CITY OF
FORT LAUDERDALE

TO: Honorable Mayor and Members of the Fort Lauderdale City Commission
FROM: Rickelle Williams, City Manager *RW*
DATE: May 5, 2025
SUBJECT: New Police Headquarters — Phase 2 Peer Review

Fort Lauderdale Police Headquarters
WJE Peer Review, Phase 2 – Building Structural Design Peer Review

Figure 5. Detail 2 from Sheet HQ-S6-1-03 which shows CMU wall foundation for wall footings that have WF# designation on the foundation plans. Note that the vapor retarder under the slab-on-ground does not pass under the wall footing

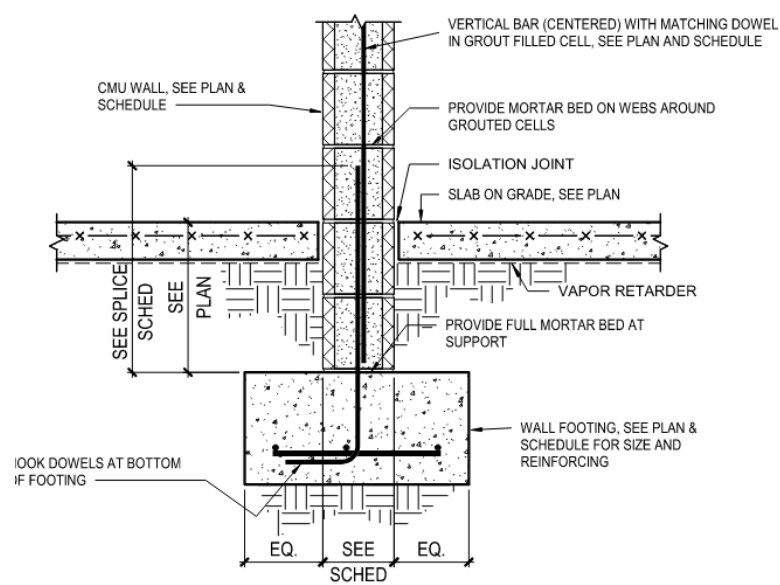
- **Masonry Wall Connection Details at Top and Bottom of Wall.** Both 7/HQ-S7-1-02 (Figure 4) and 2/HQ-S6-1-01 (Figure 5) indicate that the vertical reinforcement at the bottom of the CMU walls should be lapped with dowels. These dowels were to extend into the footing, or thickened slab, and be hooked. At the top of the CMU walls, two details are provided on Sheet HQ-S7-1-02, which is labeled as "Typical Masonry Details". Detail 3/HQ-S7-1-02 appears to be a detail for use with CMU walls that are bearing walls. A note in this detail also indicates that this detail applies when tie-beams are referenced on plan. We did not observe any tie beam references on plan, and we also did not observe on the plans where any CMU walls were explicitly designated as bearing walls. As such, Detail 3/HQ-S7-1-02 appears to not be applicable to the interior masonry walls. A wall schedule shown on HQ-S6-1-01 (see Figure 6) also does not explicitly designate any of the CMU walls as bearing walls. The masonry shaft noted above would necessarily be a bearing wall as it supports the end of concrete joists, but all other walls (not within Area E) appear to be non-loadbearing walls and in fact are believed to have been constructed as infill after the concrete structure was built. Detail 6/HQ-S7-1-02 (Figure 7) is further divided into two details, a typical detail that applies to both interior and exterior walls and an alternate option that applies to interior walls only. The typical detail shows the vertical reinforcement of the CMU wall embedded into the slab above. No minimum embedment depth is provided, but the details note that the slab thickness must be a minimum of 4 ¾ inches. Section 042200 of the specifications, "Concrete Masonry Units" Part 2.6.C addresses "Top of Wall Anchors." This specification section is shown in Figure 8. Interior non-load bearing partition walls in Seismic Design Category A, which applies to the FLPHQ, are shown to allow PTA series anchors by either Blok-Lok or by Hohmann & Barnard (H&B). A specification sheet for PTA 420 HS anchors by H&B is shown in Figure 9. A lateral load capacity for the anchor is not provided on this sheet nor is the type of fastener (e.g., screws) required to connect the anchor to the concrete structure above. It may be that this information exists somewhere else on H&B's website, but we could not find it. As such, it is unclear to us if these anchors are approved or rated for lateral load transfer, and if so, what load they are rated for. Also unclear is the capacity that the SEOR assumed for these anchors. A rendering of the PTA 420 HS anchor at the top of a CMU wall (also taken from H&B's website) is shown in Figure 10. Note that the anchor is shown with the length of the top plate oriented transverse to the length of the wall, suggesting that its rated capacity would be applicable to out-of-plane rather than in-plane loading.

Furthermore, it is evident that the SEOR is aware of what good practices are for designing masonry shear walls, evidenced by the east-to-west spanning wall used in Area E. Unlike the partition masonry walls, that wall a) was constructed such that axial and diaphragm loads from the roof can be transferred to the wall (Figure 23), b) has vertical reinforcement that is well-anchored to develop shear-friction resistance (Figure 11), and c) has a standalone wall footing without a vapor retarder underneath it, thereby increasing the sliding resistance of the wall (Figure 5).

Figure 10. Rendering of installed PTA 420 HS anchor from Hohmann and Barnard. Image taken from <https://www.h-b.com/products/pta-series-anchors-pta-420-hs> (accessed on April 13, 2025). Note that the length of the top plate of the anchor is oriented transverse to the length of the wall

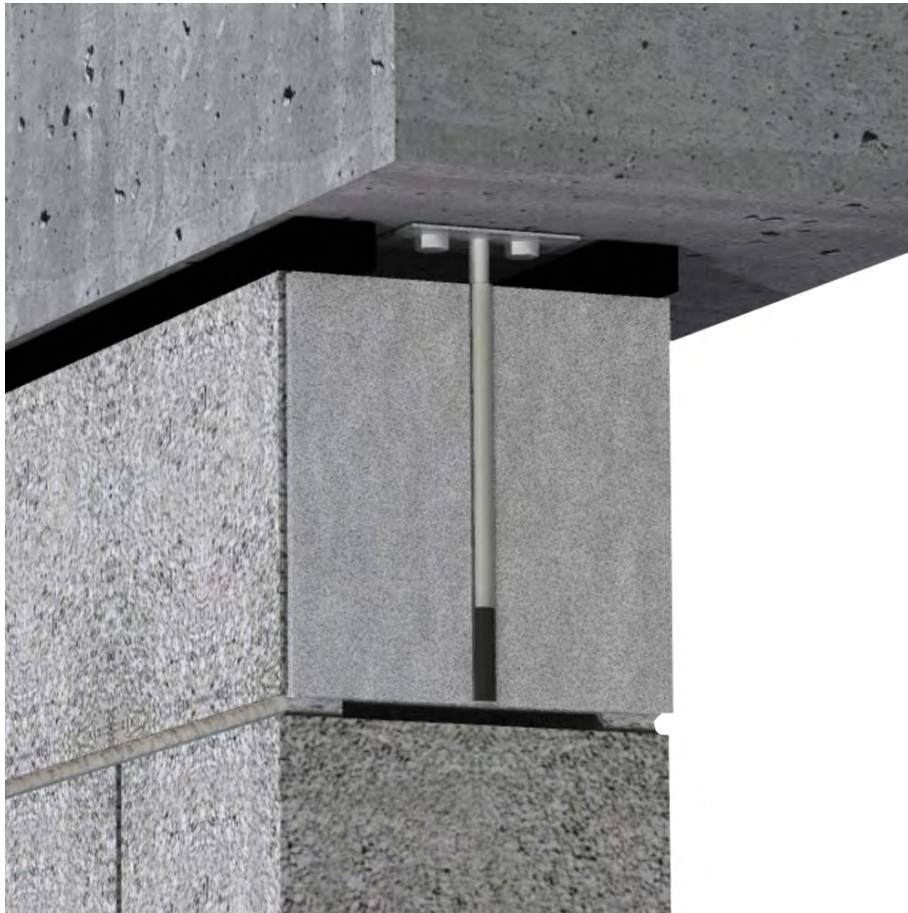
During our review of the special inspection reports, we also observed that the PTA anchors used to connect the partition masonry walls to the above floors were not oriented orthogonal to the walls, as shown on the anchor manufacturer's website. Accordingly, we recommend that the SEOR comment on which orientation of the anchors is appropriate and provide documentation from the anchor manufacturer supporting the use of that orientation.

- **Report No. 081, Dated December 19, 2023:** Comments by the TI are in regard to the concrete used in slab-on-ground Pour 3. However, photographs of CMU walls in the first story are also shown in the report (Figure 17). These photographs show the overall CMU wall construction at one location in the first story and the approved PTA anchors at the top of the wall. The length of plate at the top of the PTA anchors is aligned parallel with the length of the CMU wall in contrast with the rendering shown on the manufacturer's website (Figure 10).

Figure 12. Section through joint between Area E and the main building of the FLPHQ showing the lower beam from Area A the stub column above, and the upper beam from the main building of the FLPHQ. The slide bearing is located at the top of the stub column

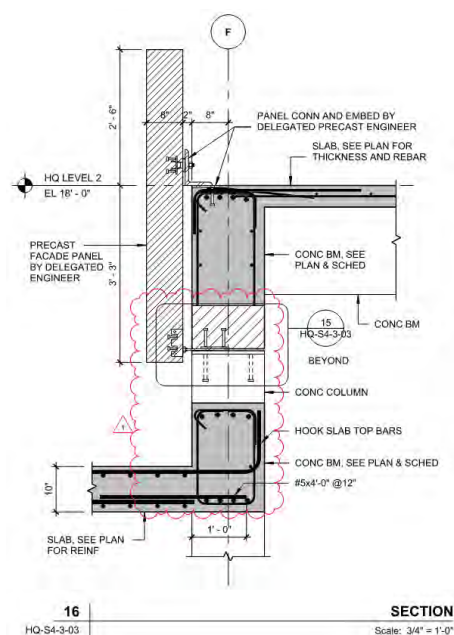
- **Slide Bearings.** The SEOR has incorporated slide bearings into their design at the joint between Area E and the main portion of the building. These slide bearings are intended to allow the two buildings to move somewhat independently under lateral and thermal loading while transferring gravity loads across the joint. These slide bearings apply to columns at Grid Points F/3 and F/4. Figure 12 shows a section of the lower beam from Area E, a stub column extending up to the slide bearing, and the upper spandrel beam from the main building above the slide bearing. Figure 13 shows the detail for the slide bearing and calls out the specific slide bearing to be used, which is Con-Serv CSA slide bearing. Con-Serv’s website indicates that the CSA bearings have an allowable bearing pressure of 2,000 pounds per square inch (psi) and also indicates that the total capacity of the bearing is based on the area of the lower portion of the bearing. Since the area of the lower portion of the bearing is 25 square inches (5 inches times 5 inches) in the design (see Figure 13), the allowable bearing capacity of the slide bearing is 50,000 pounds or 50 kips. Con-Serv’s website also indicates that the allowable bearing capacity reduces with temperatures increasing above 70 degrees Fahrenheit, as shown in Figure 14. Con-Serv also provides the sliding friction coefficient as a function of load (Figure 15). The results of capacity checks of these slide bearings are provided later in this report, along with checks of structural members.

The beams above the bearings may be lifted or “jacked” slightly to permit removal of the existing bearings. Care should be taken not to damage the surrounding elements while lifting the beams. If the beam cannot be lifted without damage to surrounding elements, then the beams can be supported on shoring, the near-surface layer of concrete can be removed from the stub columns, and the embedded plate (shown on Detail 15 of Sheet HQ-S4-3-03) can be removed to enable removal of the pads. The stub column should then be repaired before replacing the slide bearings and removing the shoring.

Figure 19. Photographs from Threshold Inspection Report No. 087 showing issue noted by inspector at thickened slab under CMU wall in upper left photograph and reinforcement not extending to the bottom of the slab above in the bottom two photographs

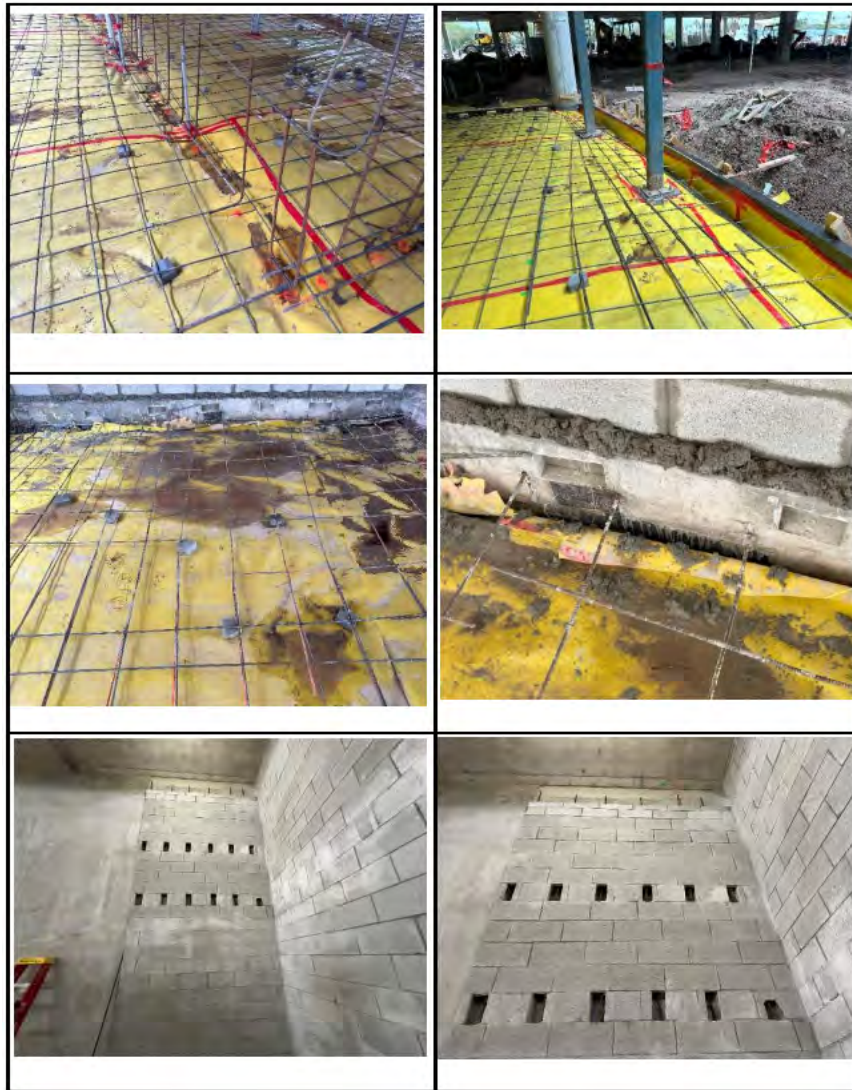
- **Report No. 087, Dated January 8, 2024:** The TI notes that "SOG pour 4 rebar. Dowels for CMU wall need to be rearranged [sic] so that the compy [sic] with detail 7/HQ-S7-1-02 for typical masonry wall on thickened slab." The TI also notes: "On CMU wall on lvl 1 area A grid line 4, rebar needs to be extended to the bottom of lvl 2 slab. See image on next page." See photographs from the report in Figure 19.

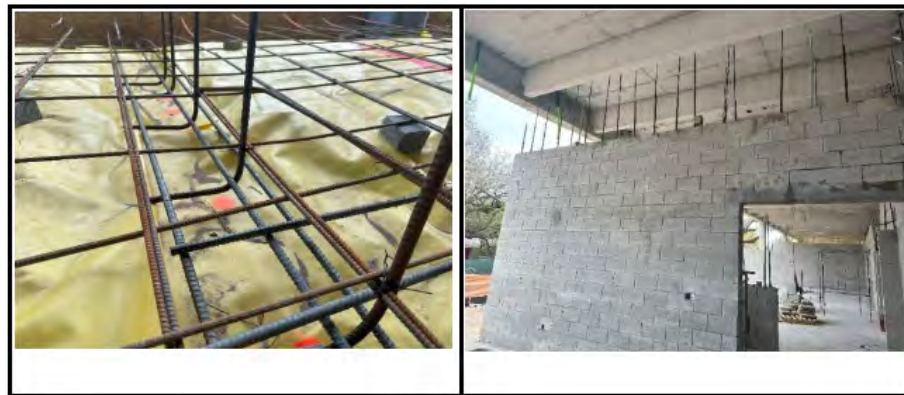
- **Report No. 107, Dated February 8, 2024:** The TI notes that “Partial inspection of slab rebar for SOG pour 5. Dowels for CMU need to be lowered to comply with what is specified on detail 7/HQ-S7-1-02.” Figure 24 shows a photograph of this condition and a photograph of a CMU wall under construction. Again, note that no shoring of the structure above is present, indicating that the CMU wall was not constructed as a bearing wall.

Figure 26. Photographs from Threshold Inspection Report No. 123 showing PTA connectors at bottom of soffit beam with only one screw attaching the plate of the anchor to the soffit beam

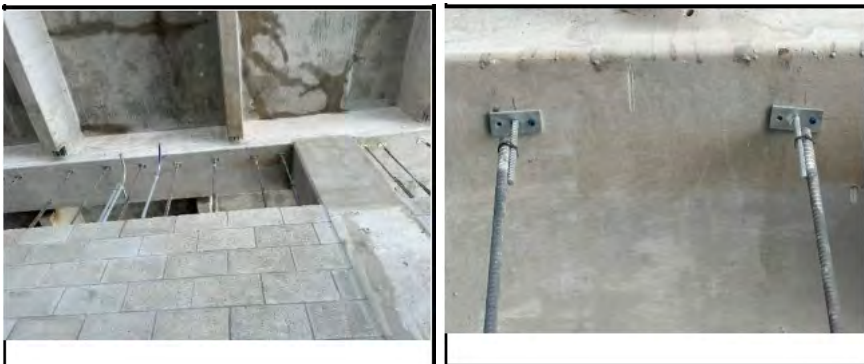
- **Report No. 123, Dated March 4, 2024:** The TI notes that “Anchors to attach the vertical reinforcement of CMU walls to soffit beams were placed with one tapcon screw instead of two how it's specified on the product specs.” Photographs of this condition are shown in Figure 26. The length of plate at the top of the PTA anchors is aligned parallel with the length of the CMU wall in contrast with the rendering shown on the manufacturer's website (Figure 10). No comments were made by the TI regarding the orientation of the anchor plate relative to the wall.

Figure 29. Photographs from Threshold Inspection Report No. 133 showing CMU wall at Level 1, Area D

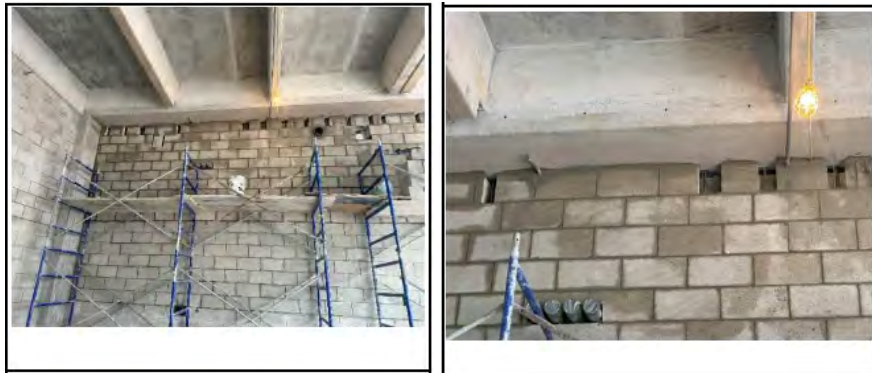
- **Report No. 131, Dated March 19, 2024:** The TI notes that "Vertical reinforcement of Level 1 area D CMU checked for adequate lap splice." Two photographs are shown of a wall that appears nearly complete (Figure 28).
- **Report No. 133, Dated March 21, 2024:** The TI notes that "Inspection of CMU on Level 1 area D between grid lines 15 and 16. Checked anchors are properly installed and rebar tied to them." See Figure 29.

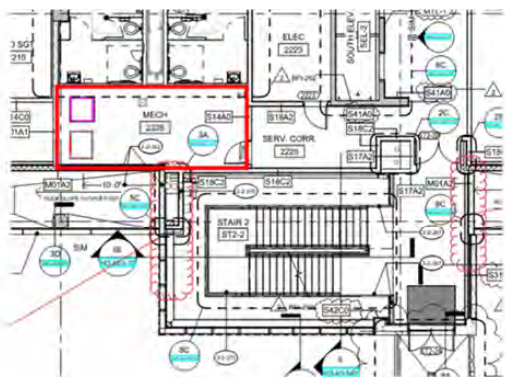
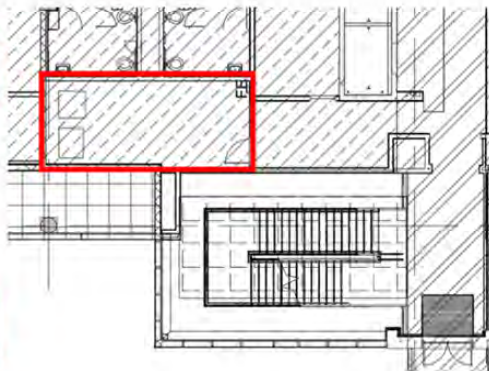
Most of the areas with mechanical equipment identified in the architectural drawings were accommodated in the structural drawings in the loading diagrams. However, we have identified one area on Level 2, south of Gridline 14, that was designated in the architectural drawings as a mechanical room but was not designated as such on Sheets HQ-S0-2-01 through 02 (Figure 30). It should be confirmed whether mechanical equipment will be installed in this area and if so, if it has been accounted for in the structural design. For our structural analysis (discussed later), we have assumed that the loading diagrams provided in the structural drawings are correct. Additionally, in some locations on the roof, both the weight of the mechanical equipment and the 150 psf allowance in live load are shown. We recommend that the SEOR confirms which load or combination of loads governed the design of the structure and specify so on the drawings. Currently, where equipment is installed, we do not know whether the equipment weight, or the specified 150 psf live load, or a combination of the two was used by the SEOR to design the structure supporting the equipment. Moreover, we recommend that the SEOR confirms if there is mechanical equipment in the area bounded by Gridlines H, J, 14, and 16 (or other areas which currently are not reflected in the structural drawings).

Figure 34. Plan view of FLPHQ showing the approximate locations of the center of rigidity and east-west wind loads. Due to eccentricity between the two, the structure twists

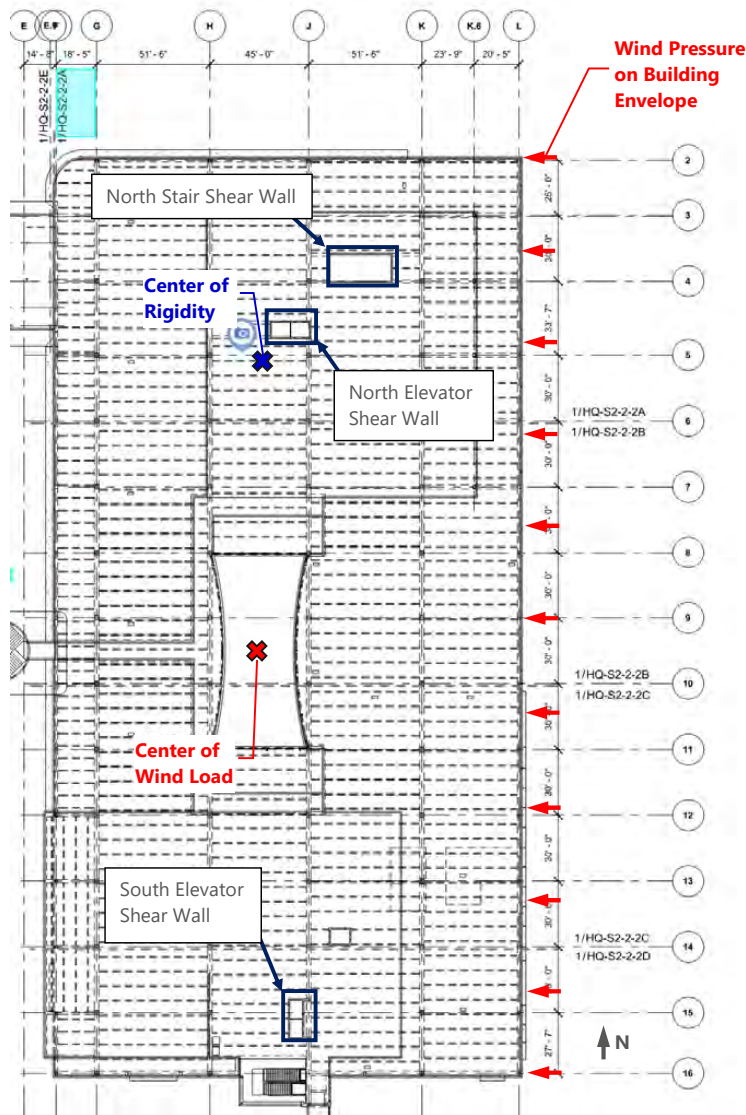
10. **Building Period.** Due to the relatively small length of shear wall in the southern half of the main building of the FLPHQ, the fundamental period of vibration of the building is over 0.9 seconds (which is significantly larger than typical concrete shear wall buildings having no more than three stories). The fundamental mode also corresponds with a twisting response of the structure. While this condition does not violate any code-prescribed performance limitations, it is not standard practice to design structures to perform this way. Adding an appropriately designed full-height shear wall (i.e., from foundation to roof) to the structure (as previously described) will rectify this condition.

length of reinforced concrete shear walls). The higher period is likely due to a) a shorter length of shear wall in the FLPHQ, and b) the differences in distribution of that wall on plan than in typical buildings of similar size, resulting in increased flexibility. The first mode shape and displaced shape of the structure when subjected to east-west winds indicate that the building is twisting in addition to laterally swaying. As conceptually illustrated in Figure 34, this twisting component of the first mode behavior is being caused by eccentricity between the center of wind loading and center of rigidity. Since there is greater lateral stiffness from the two sets of reinforced concrete core walls on the northern half of the building than the stiffness from the one set of shear walls on the southern half of the building, the center of rigidity is shifted towards the northern half of the building (approximately near Gridline 5). Moreover, since the centroid of east-west wind loading occurs roughly at the mid-length of the building, the wind loading is eccentric with respect to the center of rigidity and produces twisting. While this condition does not violate any code-prescribed performance limitations, it is not standard practice to design structures to perform this way. Furthermore, it is possible that the twisting may result in unusual serviceability-related conditions, since the lateral system of the FLPHQ differs substantially from typical practice of similarly sized buildings. Proposed measures to remediate member capacity deficiencies (discussed later) also rectify this condition.
